DOCKET FILE
OMB - MS - 016

Docket Nos. 50-317
and 50-318

REVIEW OF
RESISTANCE TEMPERATURE DETECTOR
TIME RESPONSE CHARACTERISTICS

SAFETY EVALUATION BY
U.S. NUCLEAR REGULATORY COMMISSION
OFFICE OF NUCLEAR REACTOR REGULATION
DIVISION OF SYSTEMS INTEGRATION
INSTRUMENTATION AND CONTROL SYSTEMS BRANCH

Figure 2.1 Plot of correction factor $[f(\tau_2/\tau_1)]$ vs pole ratio $[\tau_2/\tau_1]$.

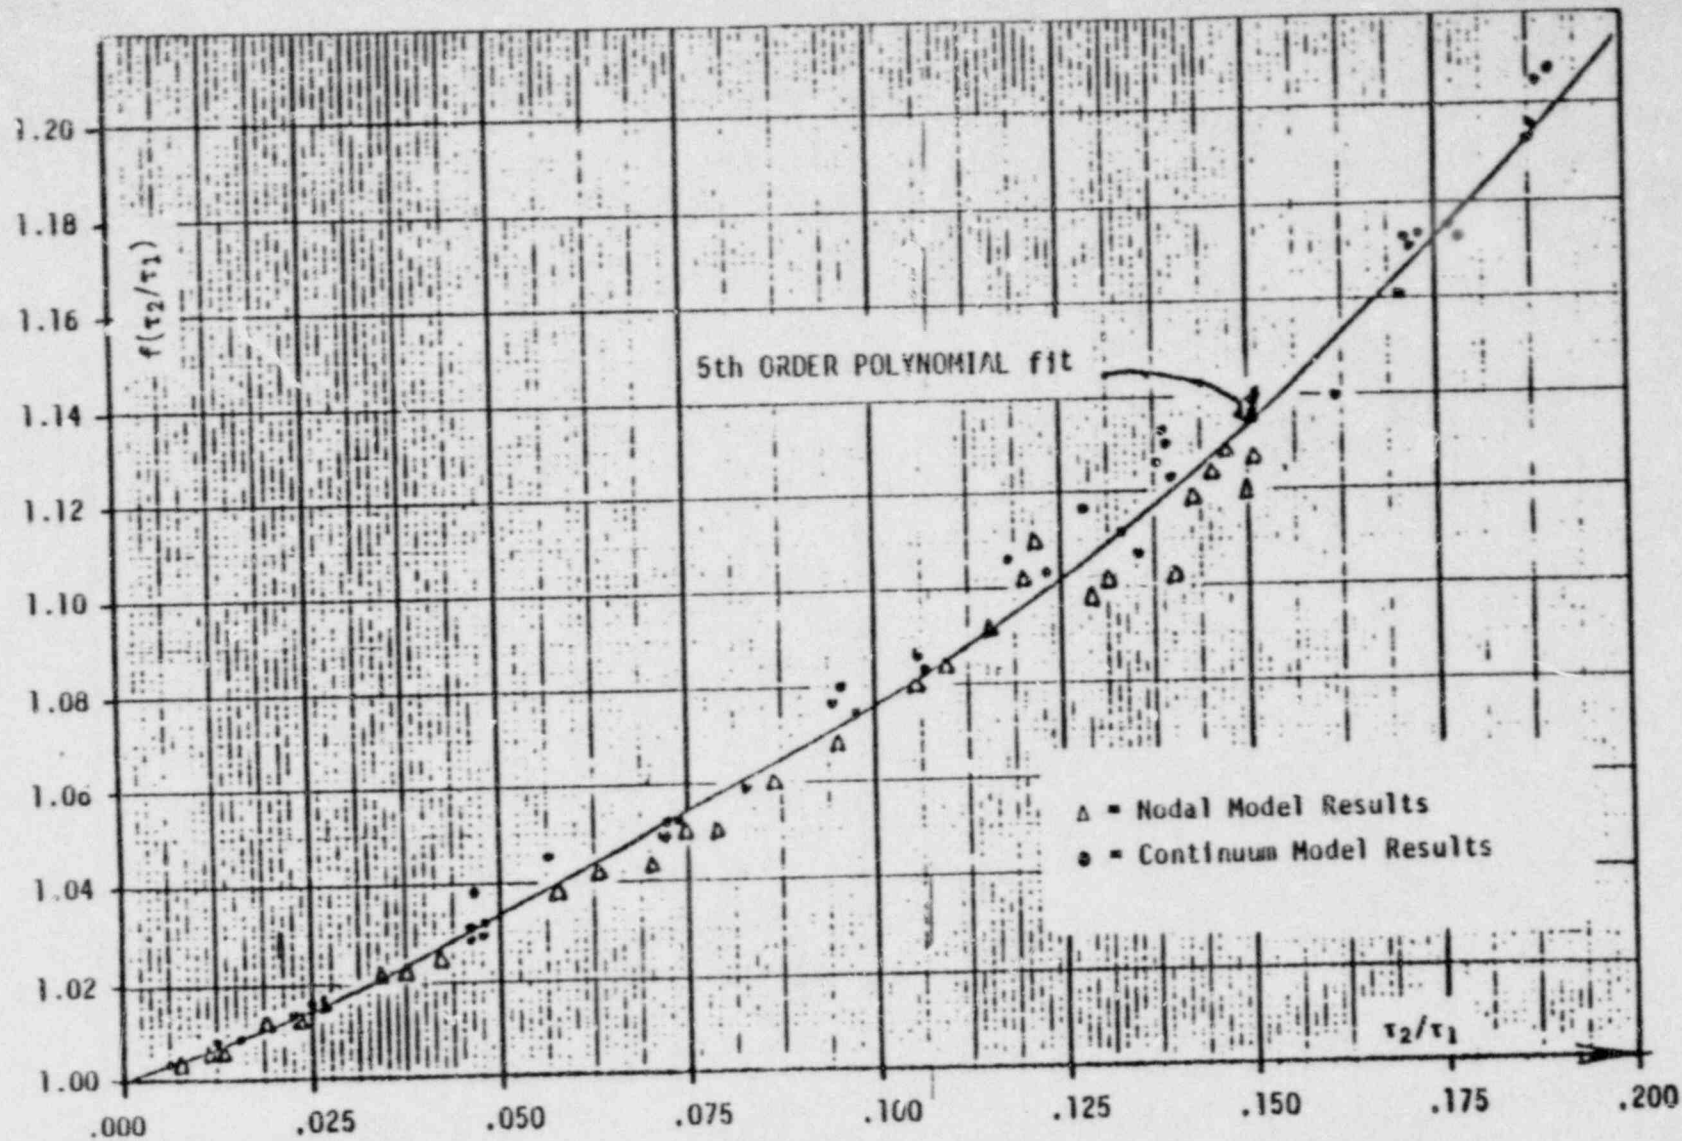
where $f(\tau_2/\tau_1)$ is given by the empirical relationship of figure 2.1. Figure 2.1 was constructed by mathematically computing the Plunge τ (equation 2.2) and $\tau_1 [1 - \ln(1 - \tau_2/\tau_1)]$ for a number of different hypothetical RTDs and plotting the ratio of the two. The hypothetical RTDs had a variety of sized and geometries, which included both hollow core and central element RTDs. Thus the curve of figure 2.1 applies to any RTD which fulfills the two requirements of section 2.2.2. The fact that this large variety of RTDs all enjoy the same $f(\tau_2/\tau_1)$ is, on the surface, rather amazing. With such a good correlation, one would naturally be inclined to search for an underlying physical reason for all RTDs to display the same $f(\tau_2/\tau_1)$. However, to date this underlying physical relationship has eluded us.

Figure 3.1 Empirical Correlation Curve for Plunge τ versus LCSR τ for Rosemont RTD Model 104AFC. (Combustion Engineering RTD)

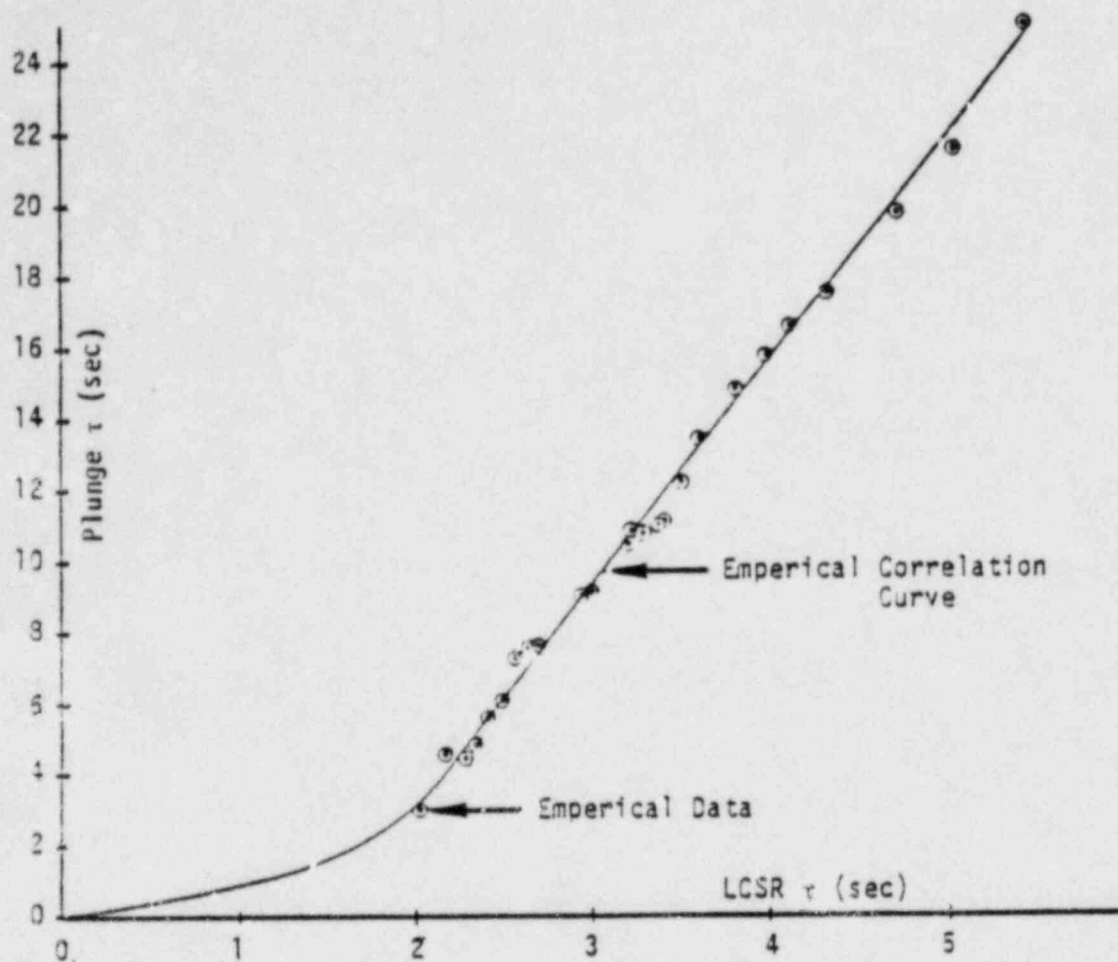
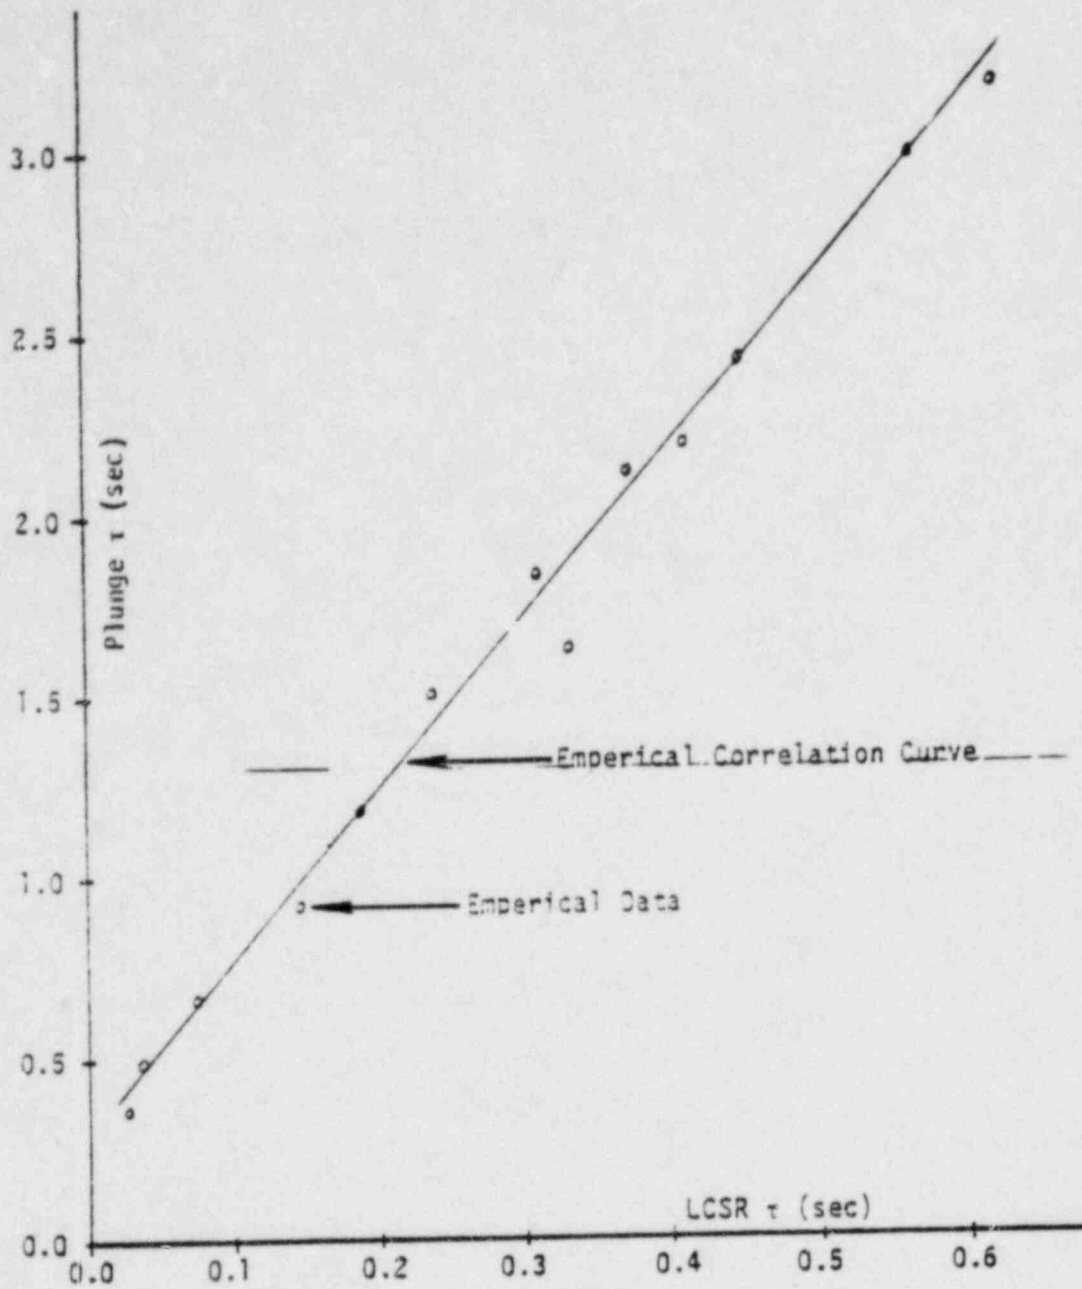
The U of T investigators attempted to correlate the Plunge τ with the LCSR τ . In making this correlation the time response of the RTD was varied by adding tape or rubber insulation around the RTD and measuring both the Plunge τ and the LCSR τ . Two such correlations are shown in figures 3.1 and 3.2.

An obvious difficulty with this method is the following: This correlation was formed by altering the thermal resistance on the surface of the RTD. When an RTD degrades, it is most likely due to increases in the thermal resistance of the RTD internals or the RTD-thermowell gap. Therefore one would expect to find a different correlation for normal degradation than that determined by adding insulation to the surface of the RTD. For this reason we do not, at present, consider the correlations of figures 3.1 and 3.2 to be sufficiently well substantiated to be used in the determination of the Plunge τ .

While not providing an accurate means of computing the Plunge τ , these correlations are useful for the degradation test. If in a degradation test the LCSR τ is found to increase, then from the correlation the approximate increase in the Plunge τ can be determined. If the Plunge τ determined in this way is near the value assumed in the safety analysis, this would indicate that it is necessary to measure the Plunge τ via the usual LCSR procedure.

Figure 3.3 Empirical Correlation Curve for Plunge τ versus SHI for Rosemont RTD Model 104AFC. (Combustion Engineering RTD)

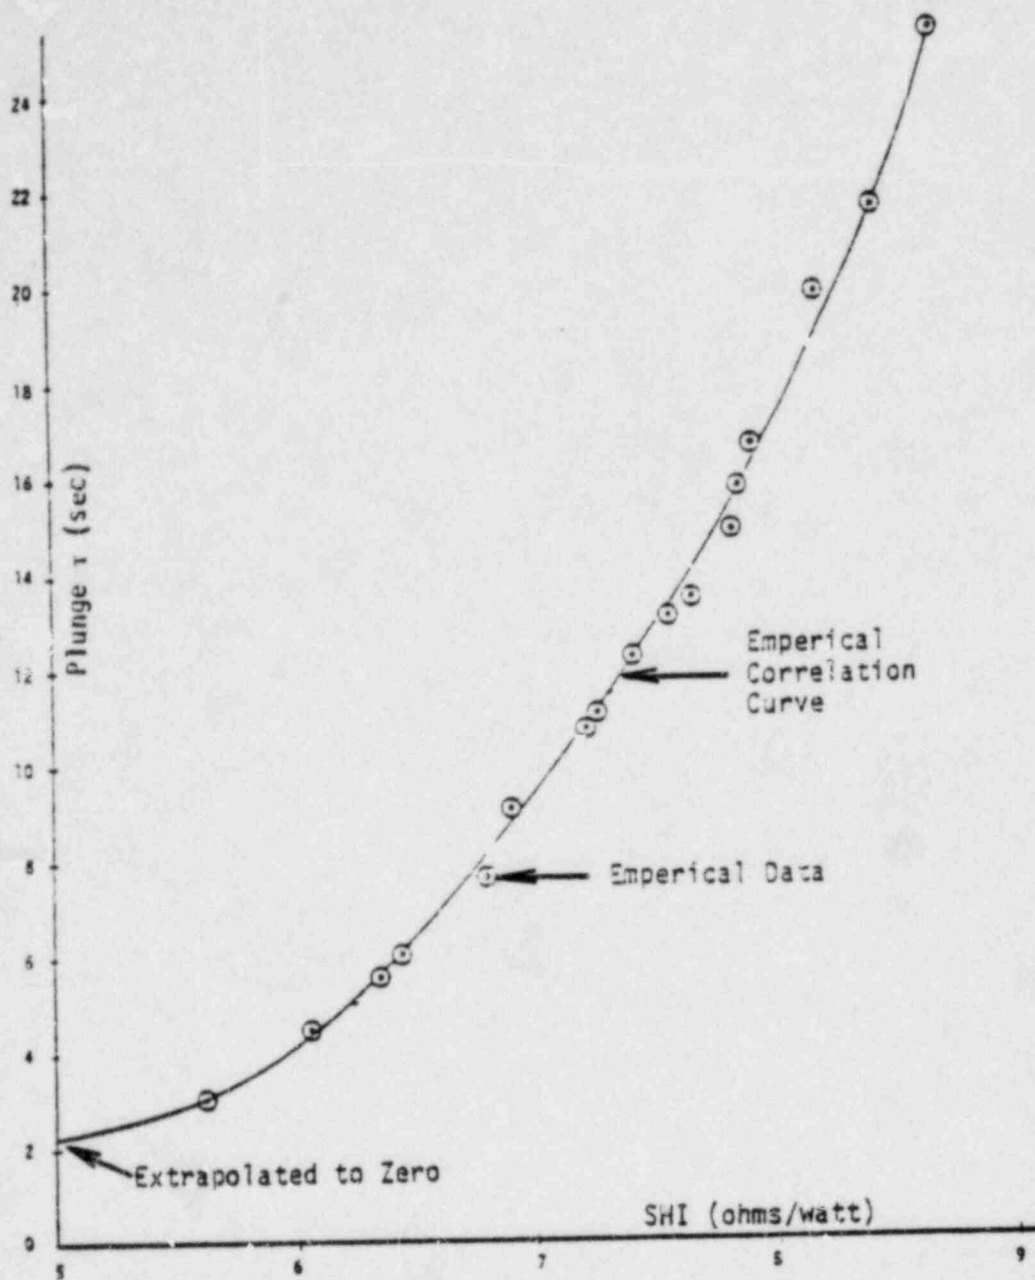
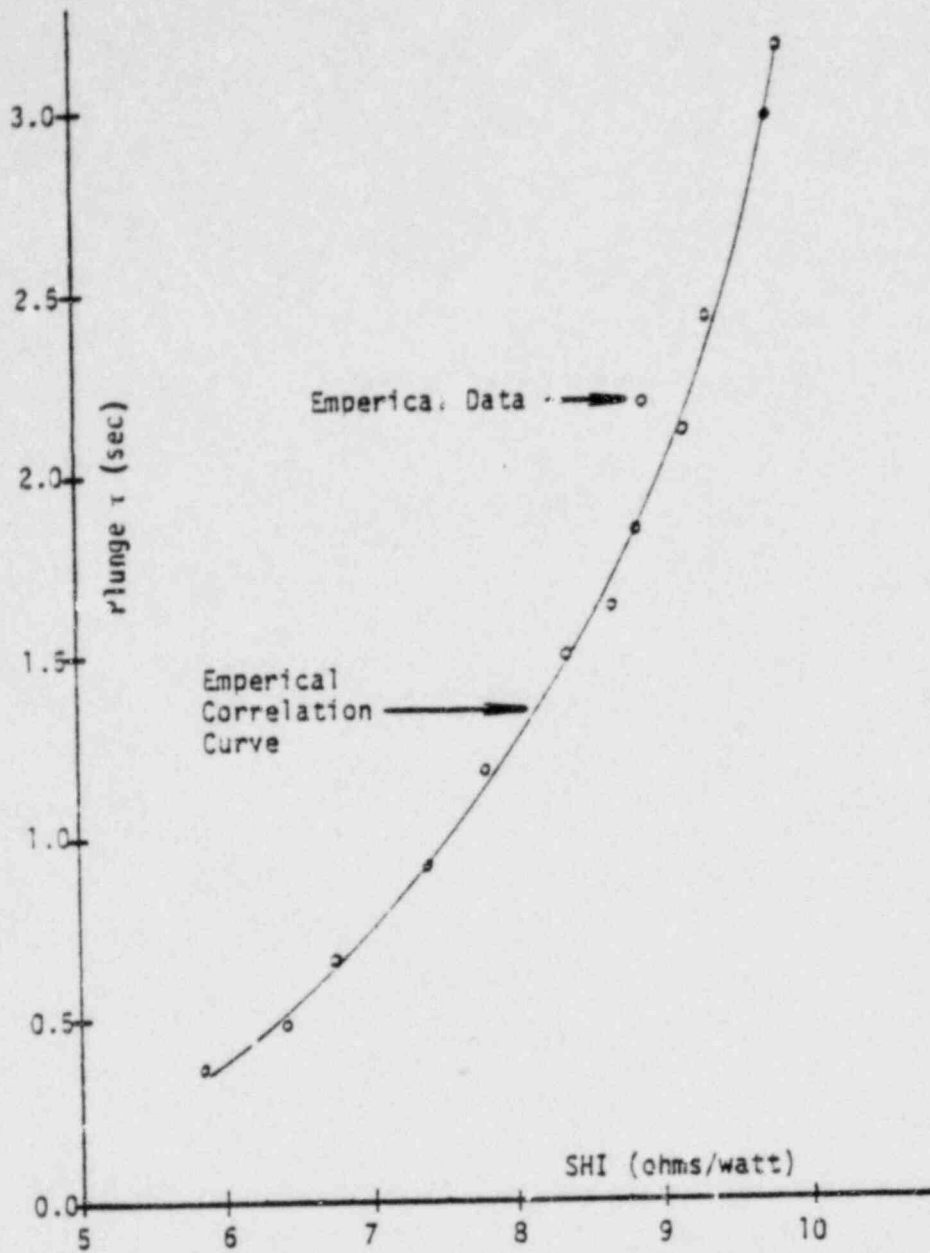
As with the LCSR τ , the U of T investigators attempted to correlate the SHI with the Plunge τ .

Again, as with the LCSR τ measurement, the RTD time response was varied by adding insulation to the surface of the RTD, and plots of Plunge τ versus SHI were constructed. Two such plots are shown in figures 3.3 and 3.4. These correlations suffer the same problem as the Plunge τ versus the LCSR τ correlations, and thus we do not, at present, accept them as viable means for computing the Plunge τ . However, like the Plunge τ versus LCSR τ correlation, the Plunge τ versus SHI correlations would be useful in a degradation test.
